工程指示 / 要求簡箋(E.I.)

工程名稱：將軍澳日出康城 11

工程項目：幕牆單元件 水槽料保護鋁蓋 (鋁摺件不用鉻化) 樣板 *地盤用*

Subject: **Site Observation for Make Use of Wooden or Plastic Cover for Gutter Water Test (2nd Reminder)**

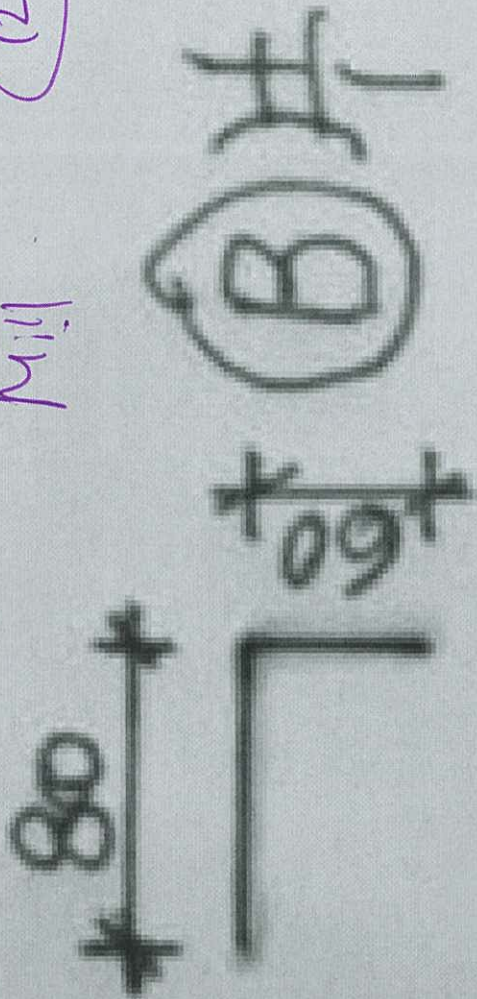
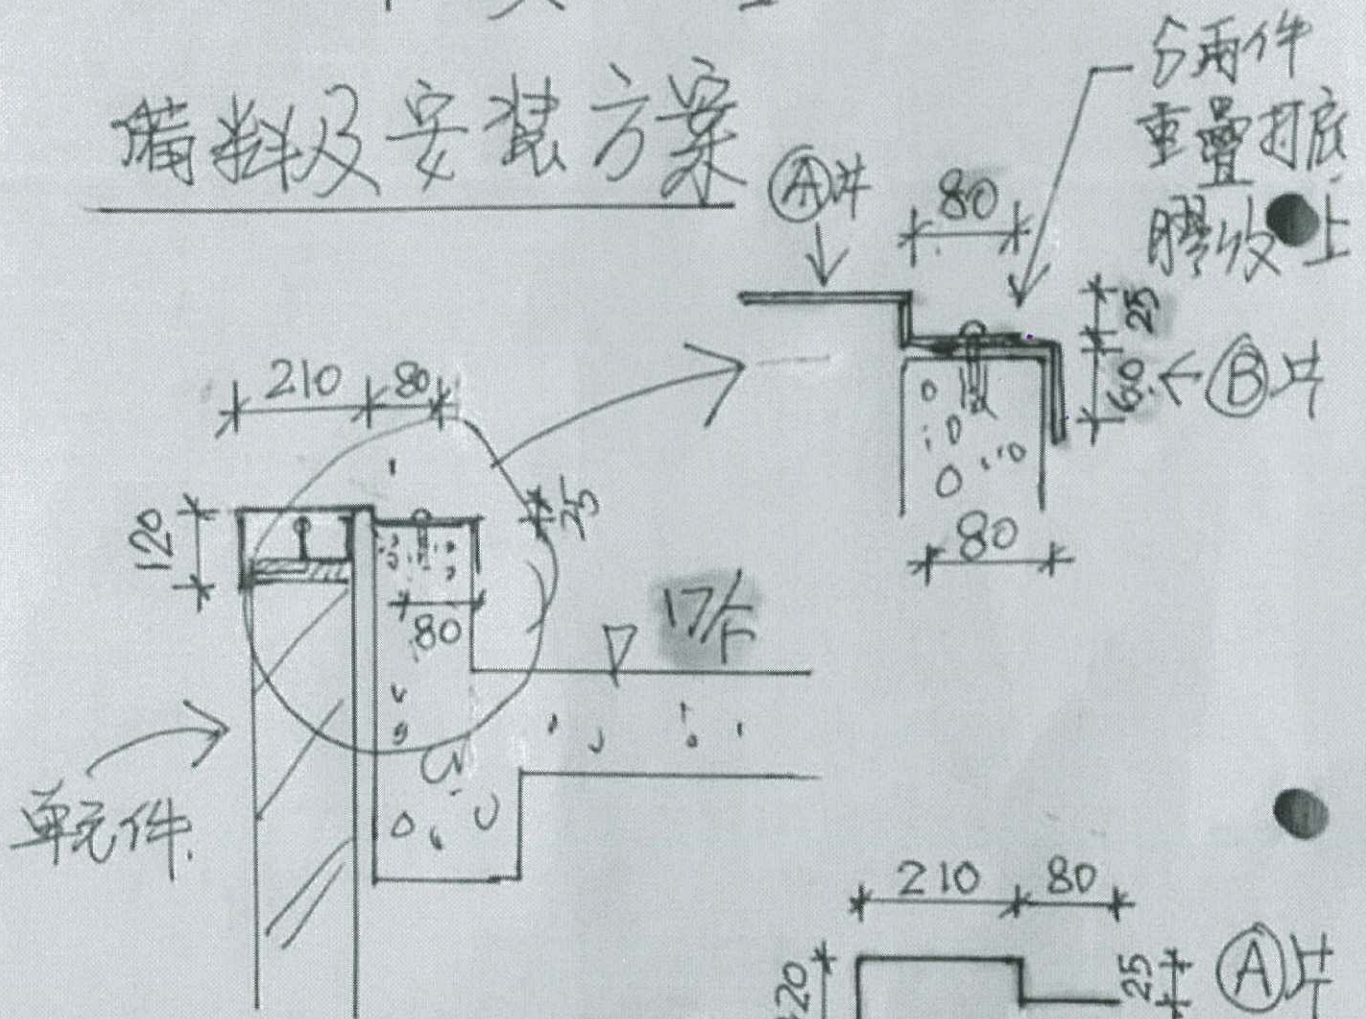
請按圖生產水槽料保護鋁蓋 (鋁摺件)

1.2mm 厚，不用鉻化 (臨時保護水槽料用)

因安裝後，頂部曝露多時需要保護。

- 1) 用 1.2 厚Mall鋁片
- 2) 長度約 2000 至 2400 1 件
- 3) 擢成呔吋(看圖示)

Photo 2

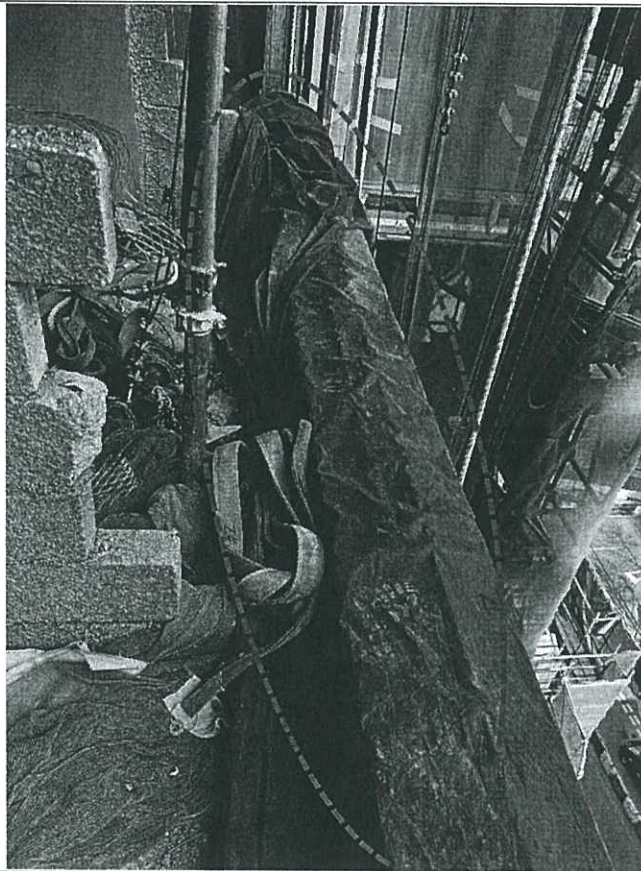
The canvas was observed to be used during units gutter water test, we recommend using wooden or plastic cover as tidy method for elimination of ambience influence.

Photo 1

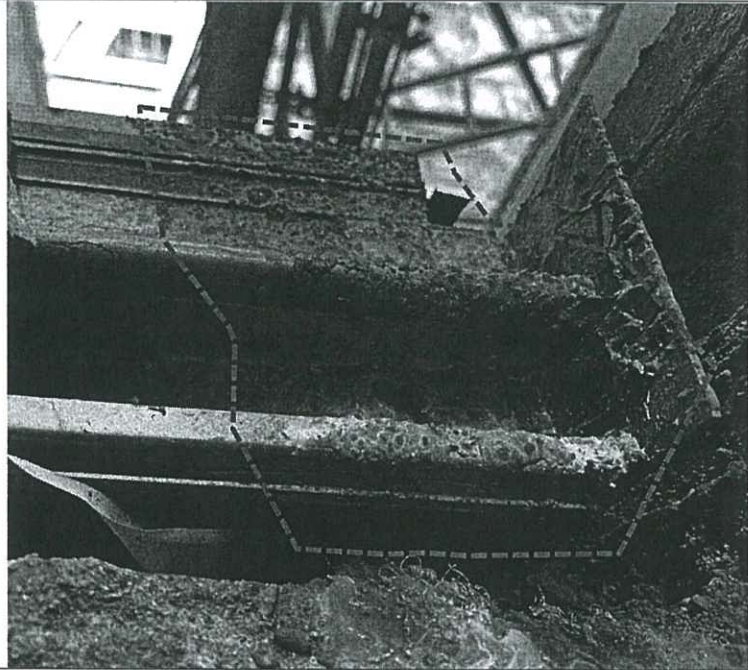
A mount of slurry was observed to exist on the transom gutter of T1 16/F installed unit.

Photo 2

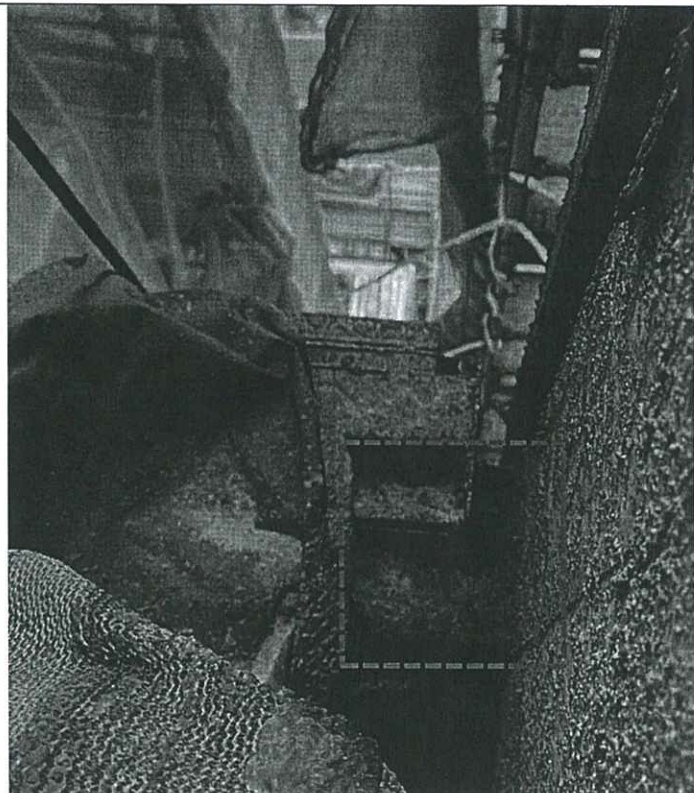
A mount of slurry was observed to exist also on the water flashing at gap between RC wall.
